**SMYRNA SCHOOL DISTRICT  
John Bassett Moore Intermediate School  
Bid Number SSD-15-002**

ADDENDUM NO. 2

29 April 2015

ARCHITECT'S PROJECT NO: 14107b

6 VEST DTL - ROOF TO EXIST  
Scale: 3/4" = 1'-0"

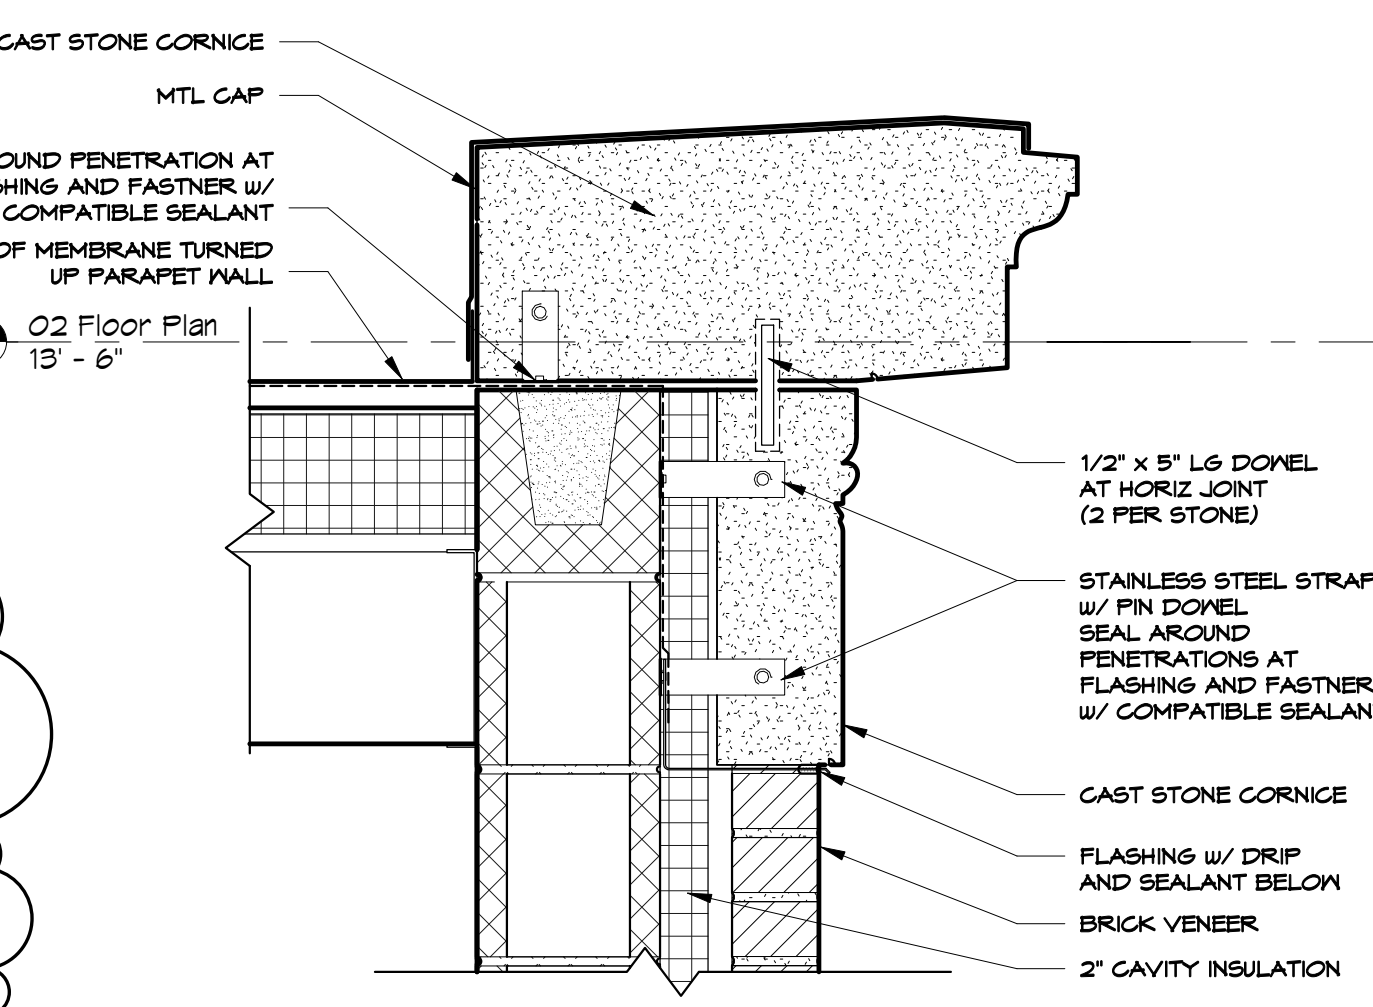
- 4.1      Detail 1/A10-01 – Opening where existing main entrance door is to be widened from 5'-10 ¼" to 6'-0"
- 4.2      Detail 4/A10-02 – Opening containing door 100A, shall increase from 5'-10 ¼" to 6'-0"
- 4.3      Door C2/ A40-01 – Overall dimension of curtainwall system to be 6'-0" Sidelight opening dimension to increase from 2'-7 ¼" to 2'-9"
- 4.4      Drawing A21-01 – Replace drawing in its entirety. Detail 6 was revised.
